From: Jennifer Atkinson <j.atkinson@manchester.gov.uk>
Sent: 22 August 2018 08:58
To: Adam Pickford; Paul Mason
Subject: Re: 1903 - NLM - Waulk Mill Coordination - 3 Windows

We have 3no windows in the Waulk Mill car park which are currently being used as a type of retaining wall for the car park. Before we remove all of the temporary blockwork in the window openings, we need to come up with a solution which is different to that currently drawn that keeps this retaining function.

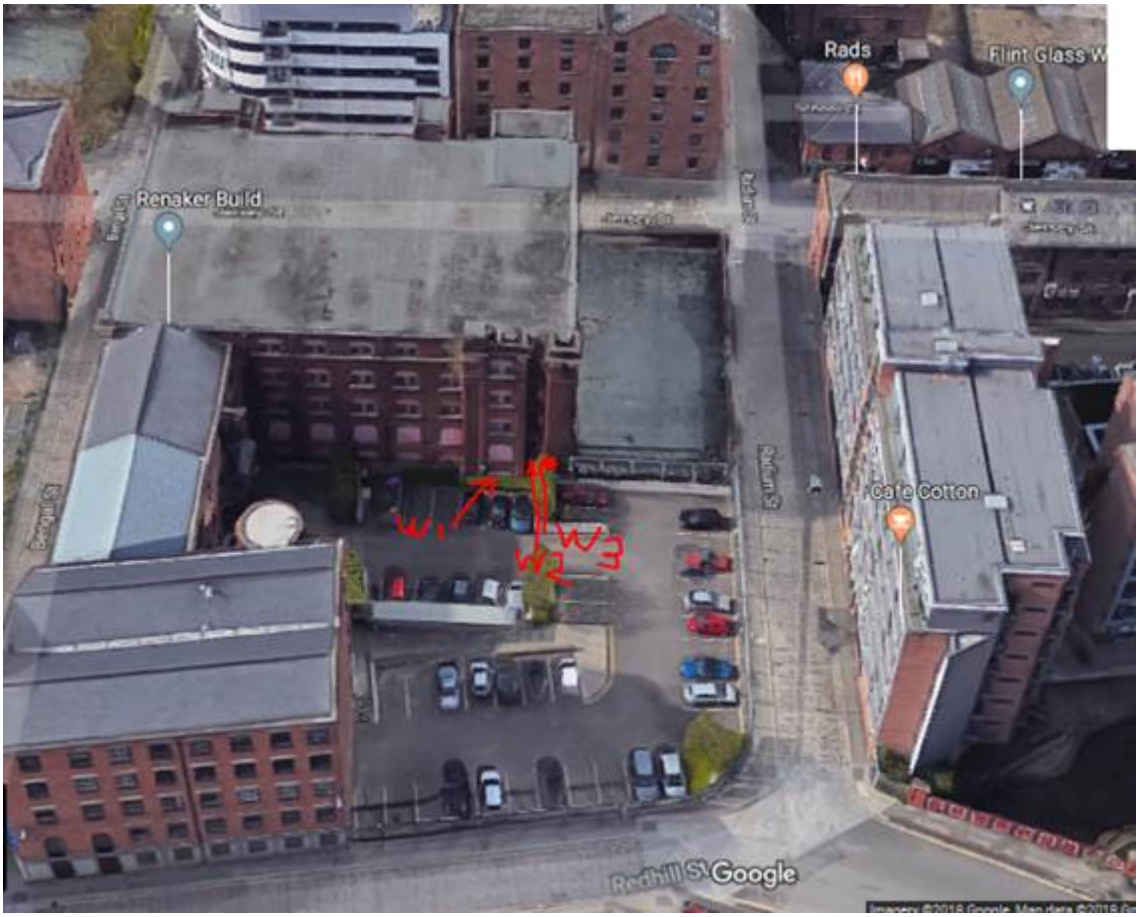
These 3 opening were due to have windows installed with backed glass so you couldn't see through them with a blockwork wall behind the window as its down to be a comms room on the inside.

I have no objection to this in principle subject to seeing the detail. Also, Paul is not in at the moment to confirm.

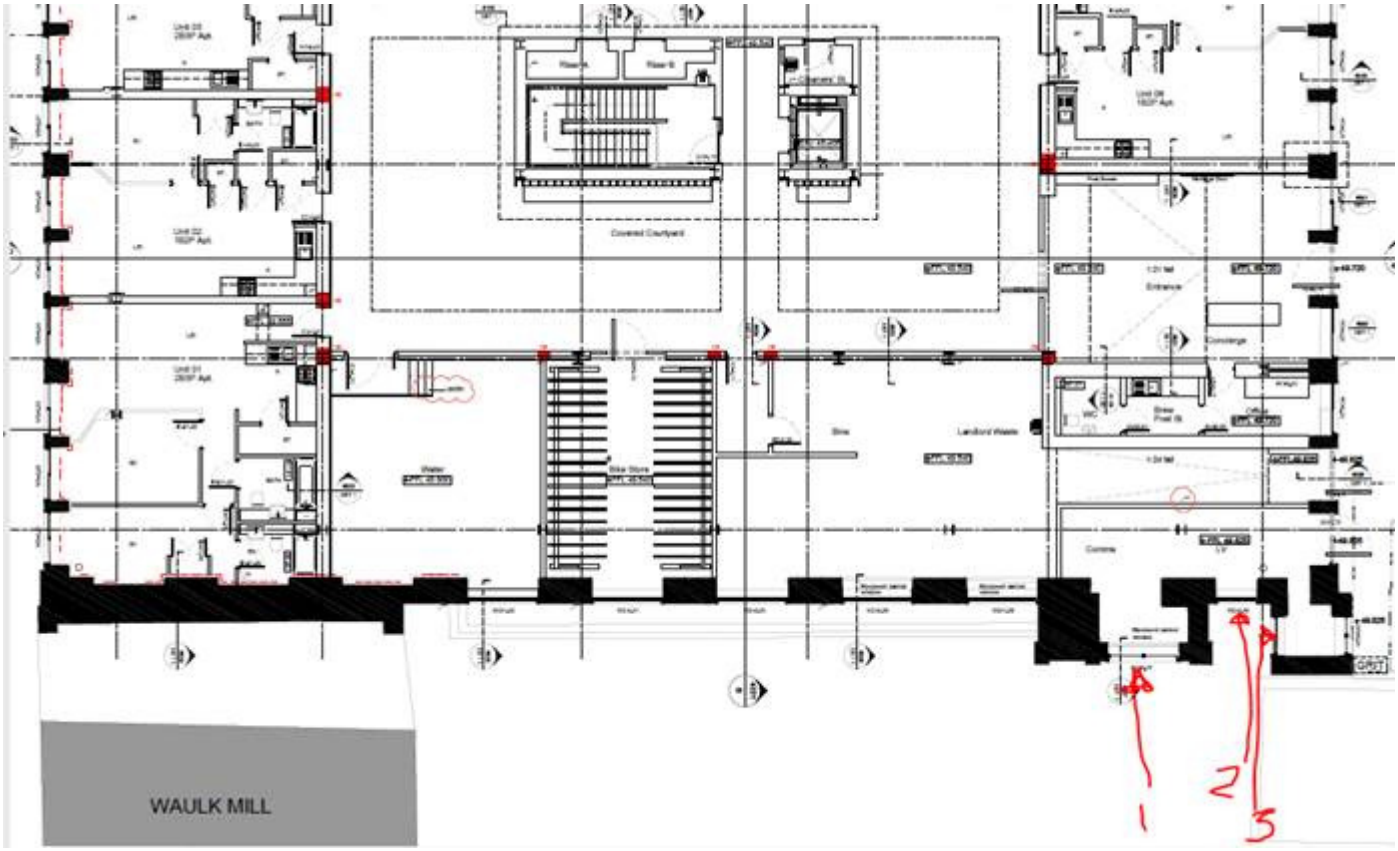
I've highlighted this problem on the attachment and also highlighted the 3 windows on the elevation and plan drawing below.

I've discussed solutions with PRP who are happy in this area to brick up the openings as long your happy and that the brick is left 25mm back from the face of the elevation to highlight that it is an opening and its current arch. These windows aren't the most visible from anywhere due to the tower recess, sorry for the poor mark-up below but it should highlight the issue and the location.

It may be worth including this change on the planning application you wish to submit.
